LIVABLE HOUSING AUSTRALIA DESIGN GUIDELINES ASSESSMENT REPORT

PROJECT:	16 Lowana Street Villawood NSW 2163
STAGE:	Design Development
REFERENCE:	22085.1-LHA
DATE:	11 th March 2024
CLIENT:	DKT Studio

Figure 2.1 – Ground floor plan

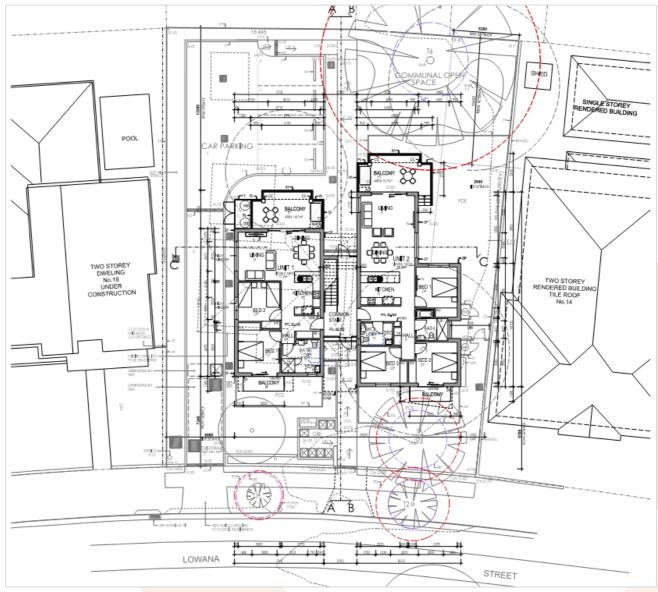
Requirement/s	Comment/s	Status
(a)	Provide a safe, continuous step-free pathway from the front boundary of the property to an entry door to the dwelling. This provision does not apply where the average slope of the ground where the path would feature is steeper than 1:14.	The pathway from the front boundary of the property to the entry floor of the ground floor dwellings, Unit 1 and Unit 2 is provided via a safe and continuous step free pathway.	С

(b)	The path of travel referred to in (a) should have a minimum clear width of 1000mm and have: (i) no steps; (ii) an even, firm, slip resistant surface; (iii) a crossfall of not more than 1:40; (iv) a maximum pathway slope of 1:14 Where ramps are required they should have landings provided at no greater than 9m for a 1:14 ramp and no greater than 15m for ramps steeper than 1:20. Landings should be no less than 1200mm in length.	The path of travel to the entry door of Unit 1 and Unit 2, referred to in (a), is provided with a minimum clear width, as required. Consideration to the surface finish along the pathway is provided to ensure that the finish is even, firm and slip resistant.	CRA

(b) A level landing area of at least 1200mm x 1200mm should be provided at the level (step free) entrance door. A level landing area at the entrance door should be provided on the arrival side of the door (i.e. the external side of the door) to allow a person to safely stand and then open the door.	A level landing area of at least 1200mm x 1200mm is identified as being provided at the arrival side of the entrance door, as required.	C

(b)	Internal corridors/passageways to the doorways referred to in (a) should provide a minimum clear width of 1000mm.	The internal corridors/passageways to the doorways referred to in (a) are provided with a minimum clear width of 1,000mm, as required.	С

Figure 3(a) Silver level ground (or entry) level toilet layout and space requirements in a separate room.

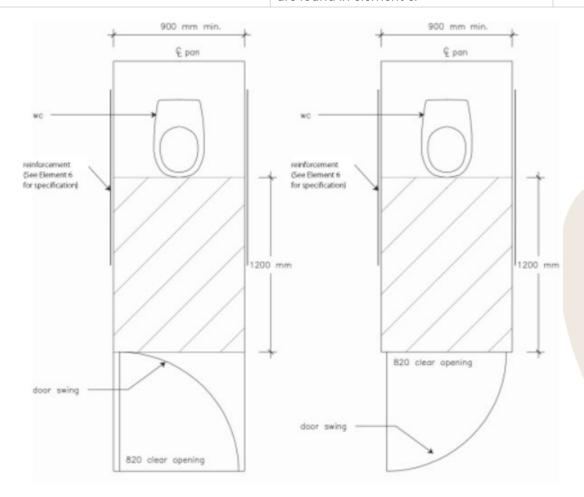
Requirement/s	Comment/s	Status
(a)	Dwellings should have a toilet on the ground (or entry) level that provides -	Unit 1 and Unit 2 are provided with a toilet on entry level having –	CRA
	 (i) a minimum clear width of 900mm between the walls of the bathroom if located in a separate room; and (ii) a minimum 1200mm clear circulation space forward of the toilet pan exclusive of the swing of the door in accordance with Figure 3(a). 	 (a) a minimum clear width of 900mm between the walls of the bathroom if located in a separate room; and (b) a minimum 1200mm clear circulation space forward of the toilet pan exclusive of the swing of the door in accordance with Figure 3(a).

The wall adjacent to the toilet pan is to be provided with provision to enable installation of grabrails at a future date. Reinforcement guidelines for walls in bathrooms and toilets are found in element 6.
